有關的規劃申請編號 The application no. to which the comment relates Y/1-DB/2

Area 6f, Lot 385 RP & Ext (Part) in D.D. 352, Discovery Bay

To rezone the application site from "Other Specified Uses" annotated
"Staff Quarters (5)" to "Residential (Group C) 12"
(Y/I-DB/2)

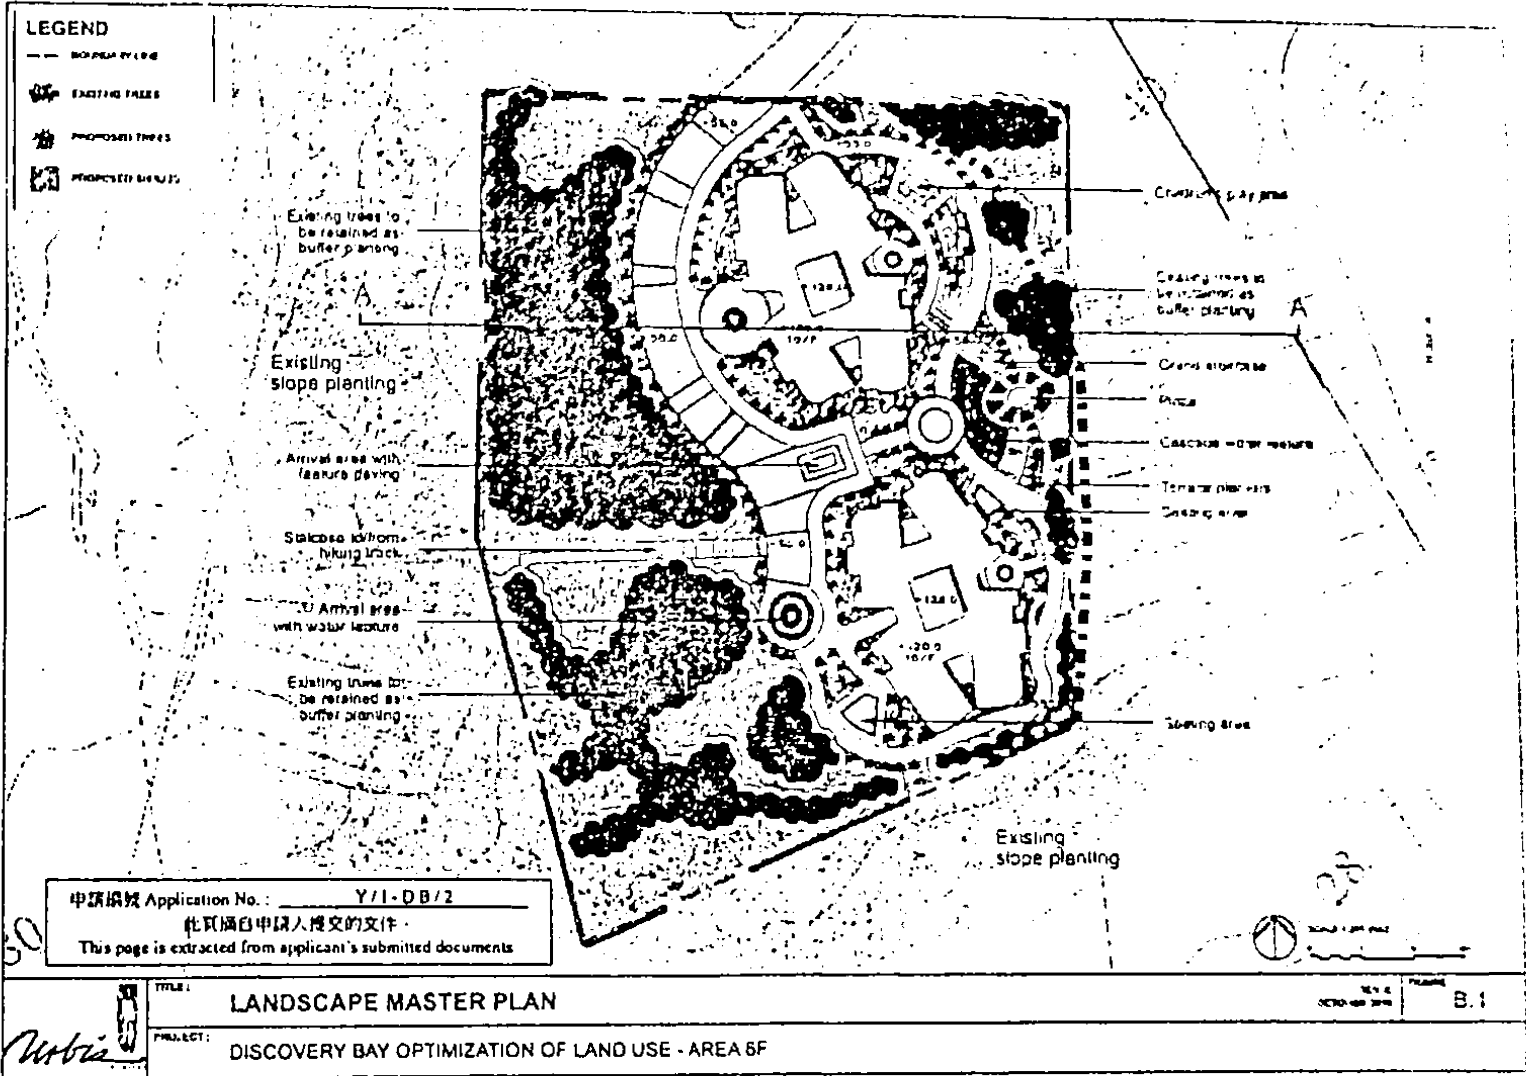
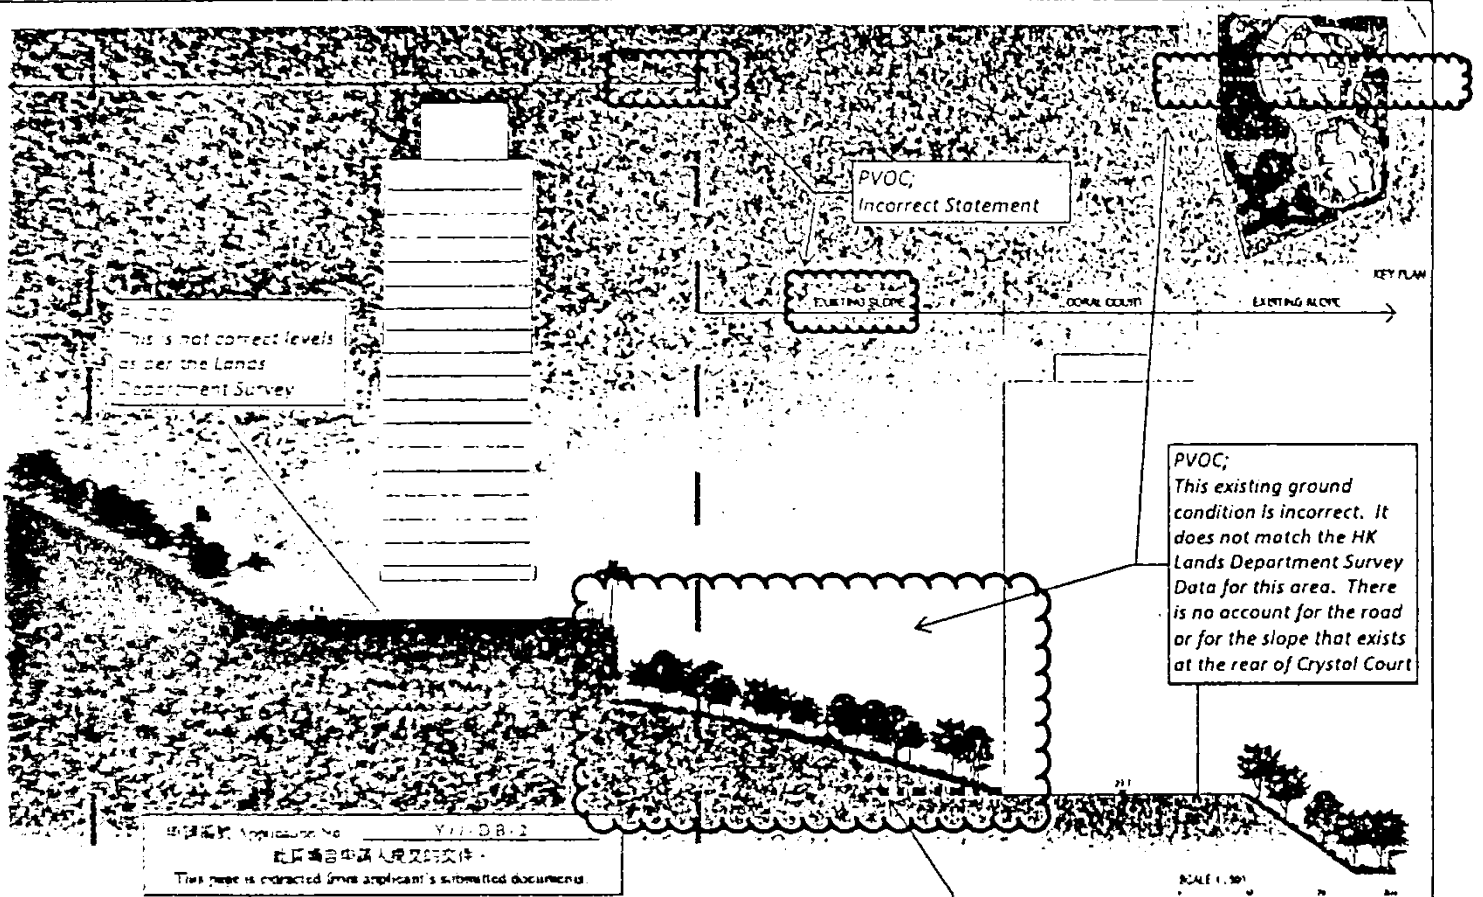
- a. Tree Treatment Plan (Annex B, page A3) and Optimisation of Land Use figure B.1.
The statement about existing tree groups to be retained is incorrect. These trees cannot be maintained based on the current plan, as there is a requirement for a large retaining structure and site formation that would not allow these trees to be left in place. Simple construction logistics would mean this would be very improbable. Also where is the approximate location of the retaining wall? The excavation for construction will remove those highlighted trees.

PVOC:
 This statement is incorrect. These trees
 cannot be maintained based on the
 current plan, as there is a requirement for
 a large retaining structure and site
 formation that would not allow these
 trees to be left in place. Also, simple
 construction logistics would mean this
 would be very improbable.

Fig. 1.1.1 AFTER IMPRESSION FROM PLAZA

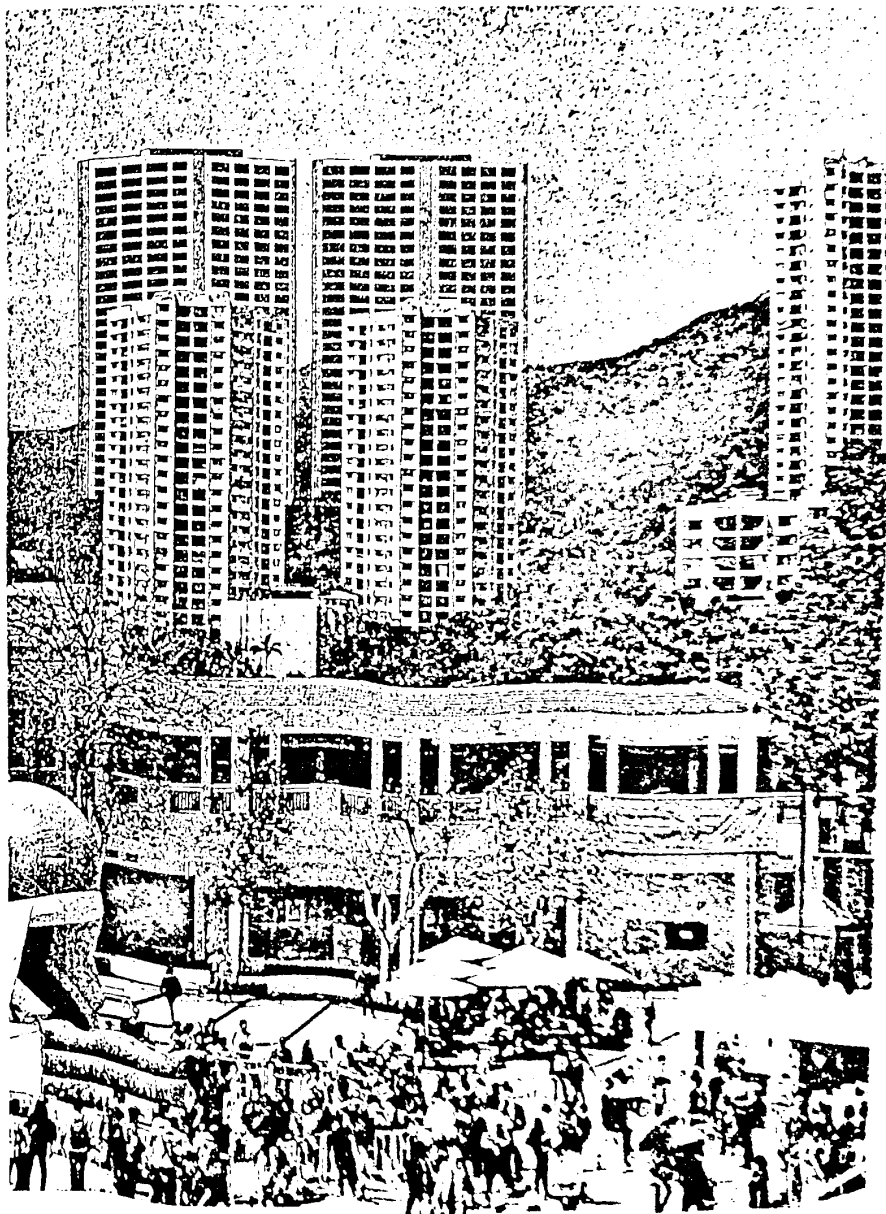
PVOC;
 These poor quality
 Photo-montages hardly
 reflect the views from the
 Lookout. The Photos are
 grainy and poorly lit.

AREA 6f
PROPOSED RESIDENTIAL DEVELOPMENT - Concept Plan

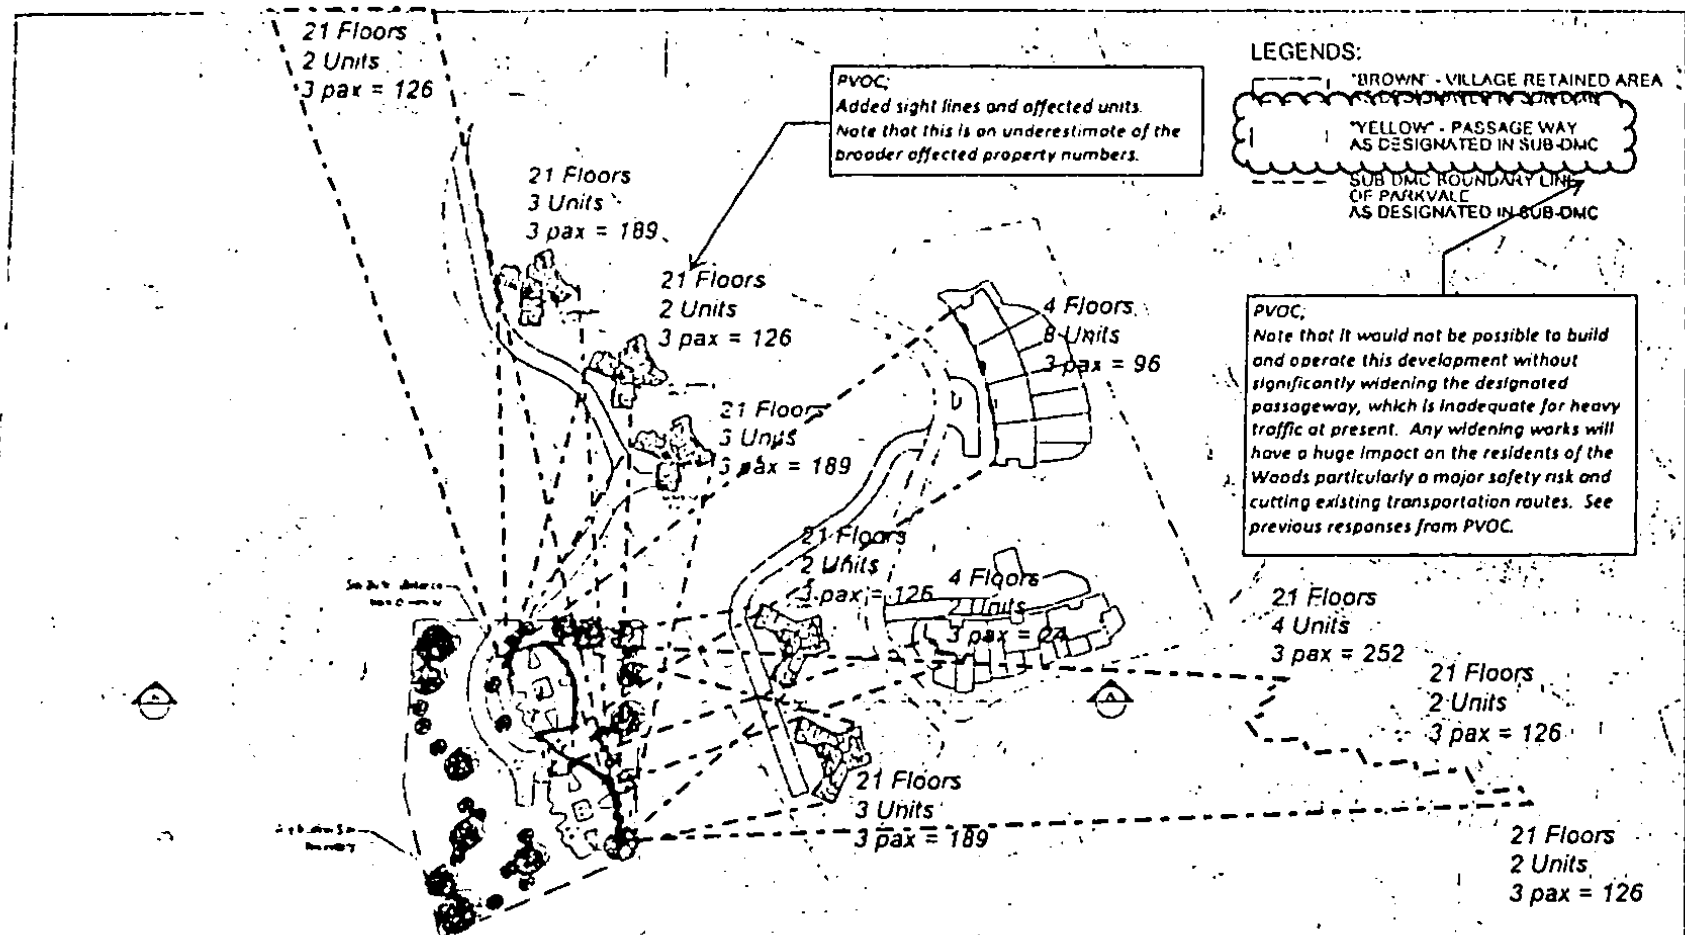
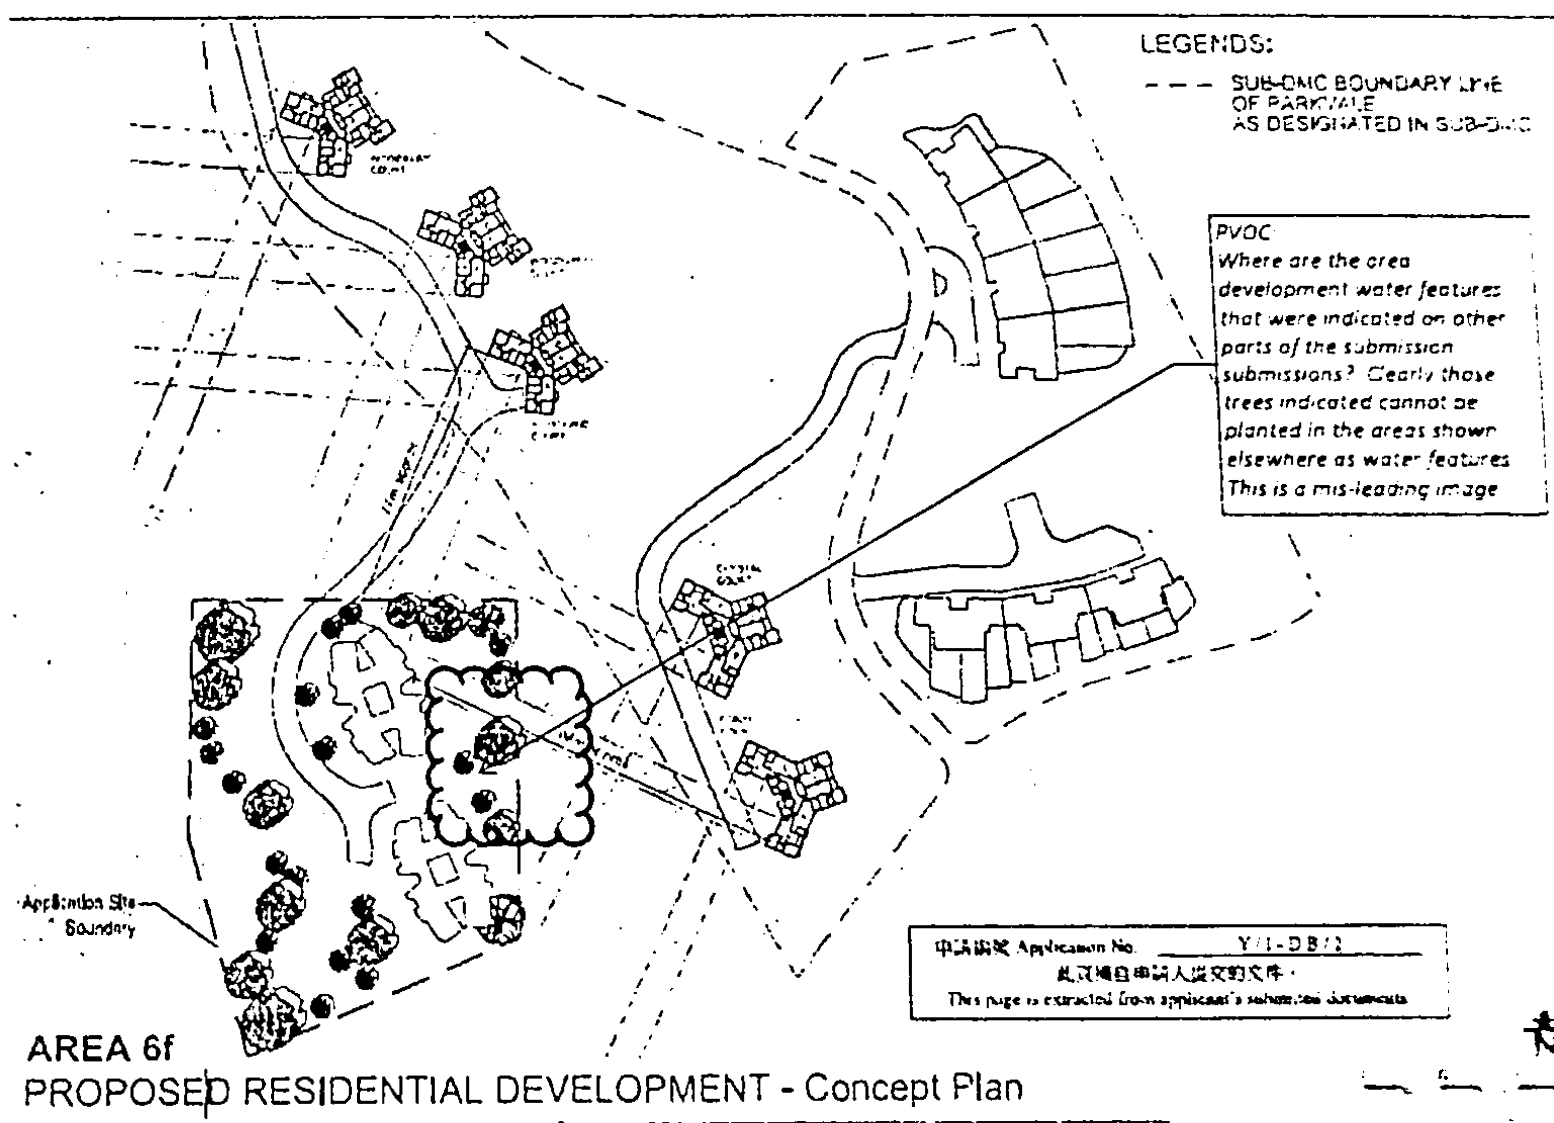
b. Optimisation of land use figure B.2. This figure includes incorrect statements about the existing slopes since the existing slope does not match the profile indicated by HKR's consultant: the existing slope profile shown in the figure does not reflect the correct levels as per the Lands Department Survey; the existing ground condition shown in the figure is incorrect since it does not match the Lands Department Survey data for this area. Furthermore, there is no account for the road or for the slope that exists at the rear of Crystal Court.

PVOC;
Existing Ground Conditions
are more like this.

100 DISCOVERY BAY OPTIMIZATION OF LAND USE - REFINEMENT OF AREA 6F				Drawing No. PT39/14/P/1507	
Drawing Title TREE TREATMENT PLAN				Scale 1:1000 (A3)	
Prepared by: [Blank] Drawn by: [Blank] Checked by: [Blank] Approved by: [Blank]				Date: [Blank] Project No.: [Blank]

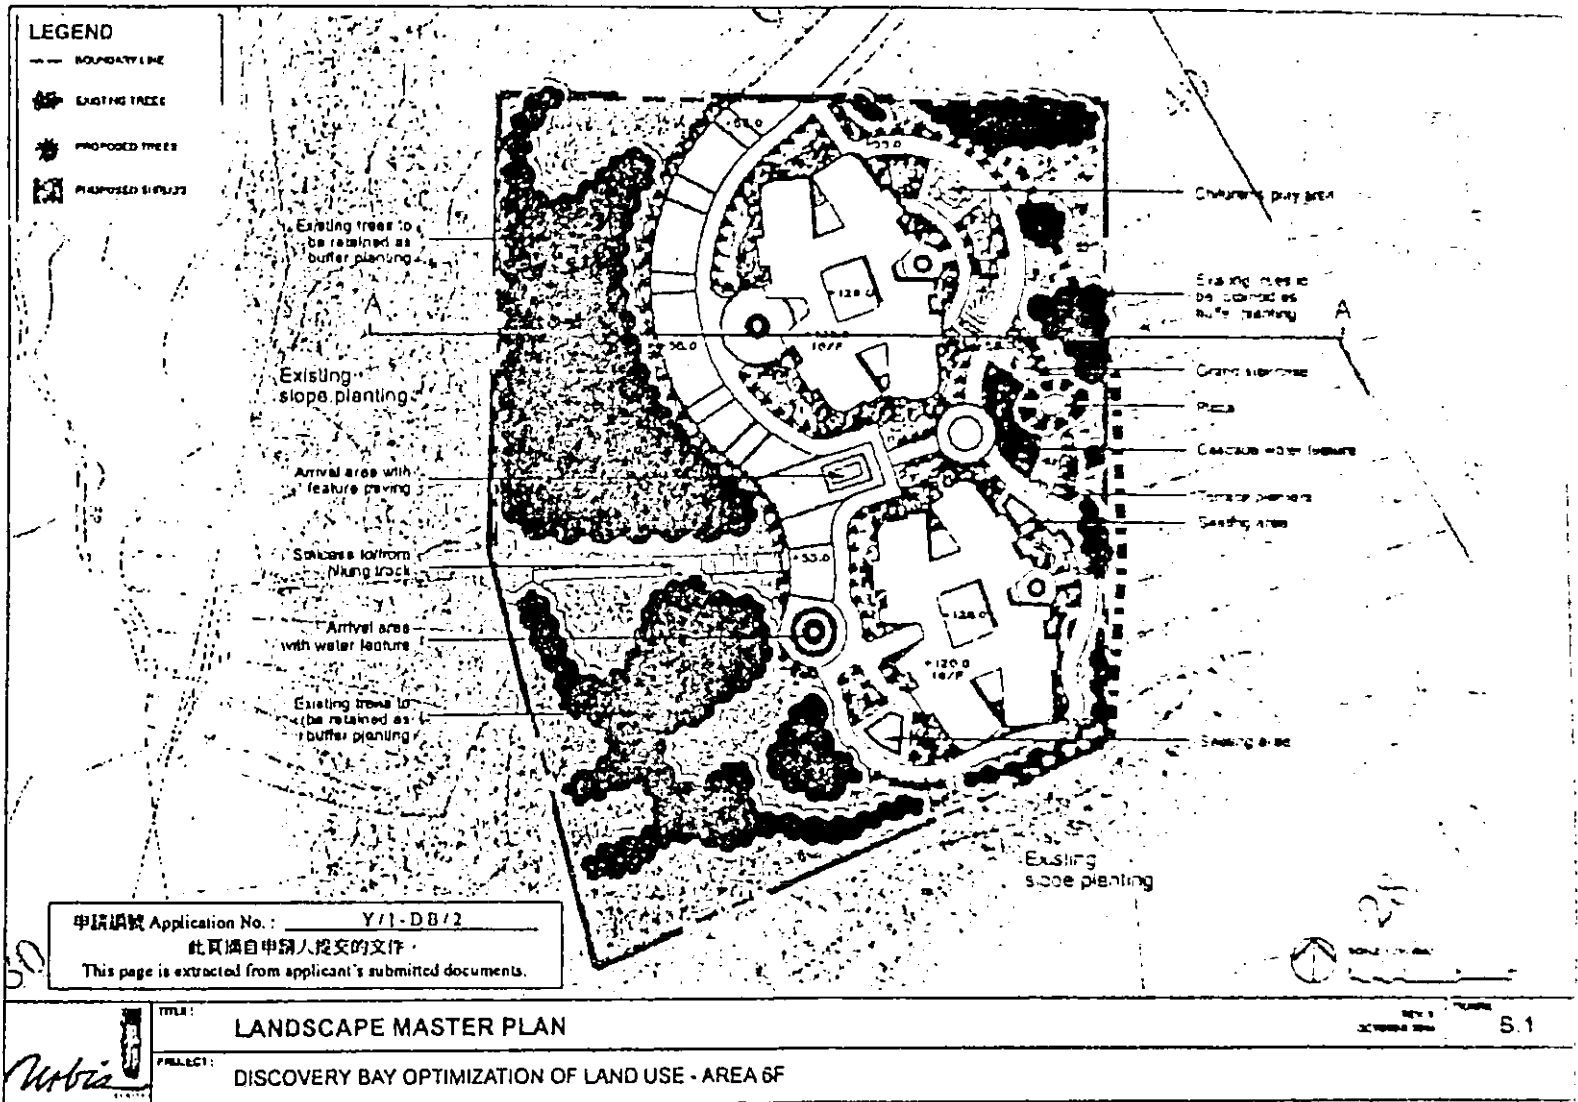
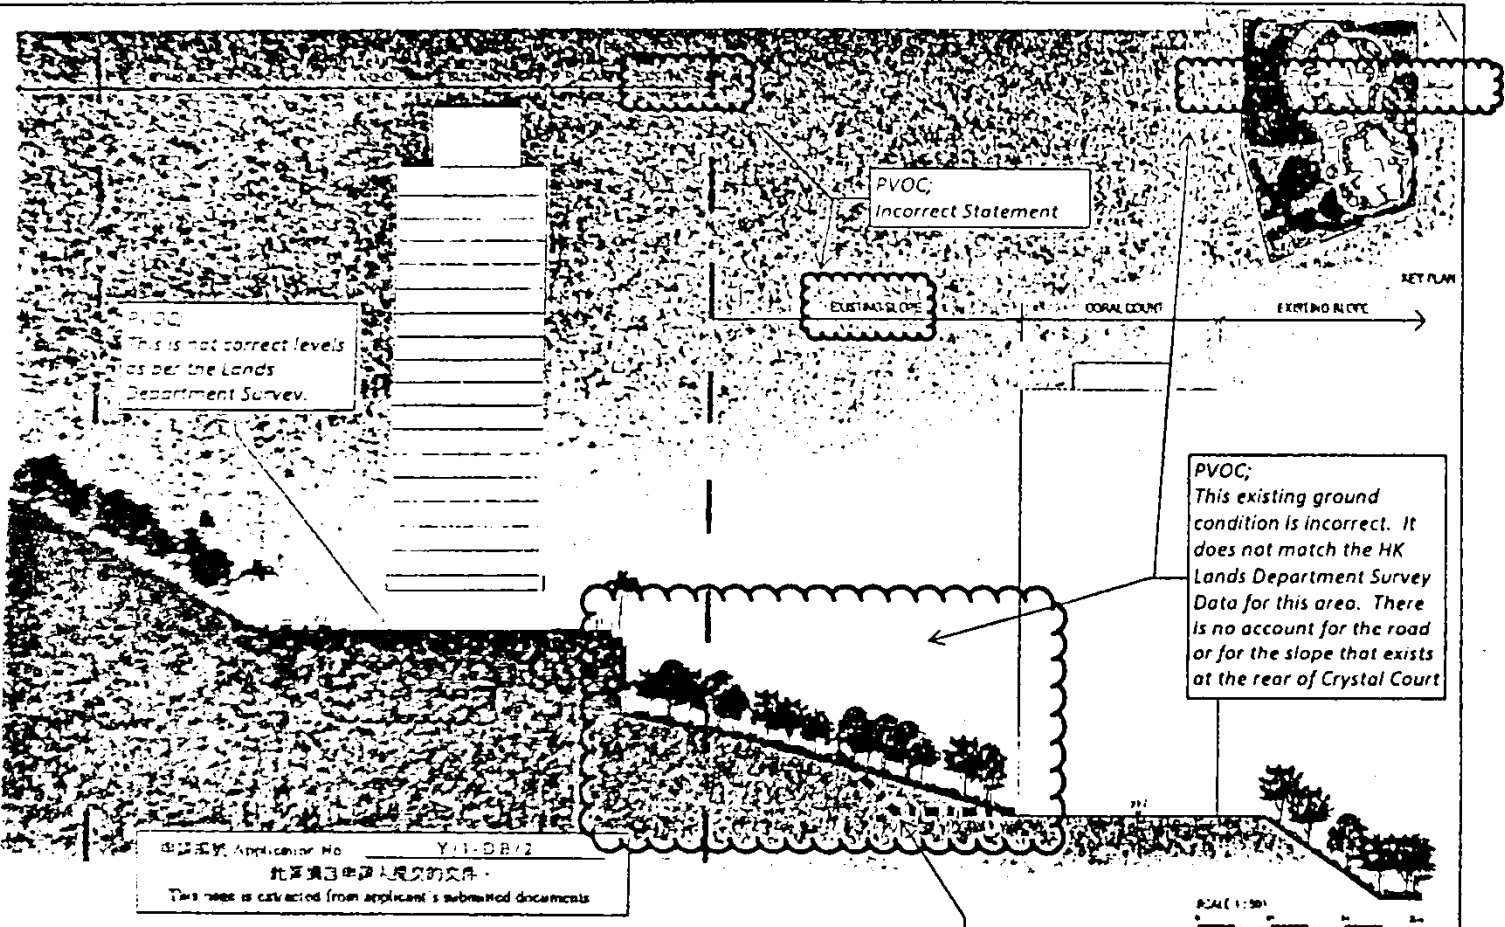
a. Tree Treatment Plan (Annex B, page A3) and Optimisation of Land Use figure B.1. The statement about existing tree groups to be retained is incorrect. These trees cannot be maintained based on the current plan, as there is a requirement for a large retaining structure and site formation that would not allow these trees to be left in place. Simple construction logistics would mean this would be very improbable. Also where is the approximate location of the retaining wall? The excavation for construction will remove those highlighted trees.

PVOC:
 This statement is incorrect. These trees
 cannot be maintained based on the
 current plan, as there is a requirement for
 a large retaining structure and site
 formation that would not allow these
 trees to be left in place. Also, simple
 construction logistics would mean this
 would be very improbable.
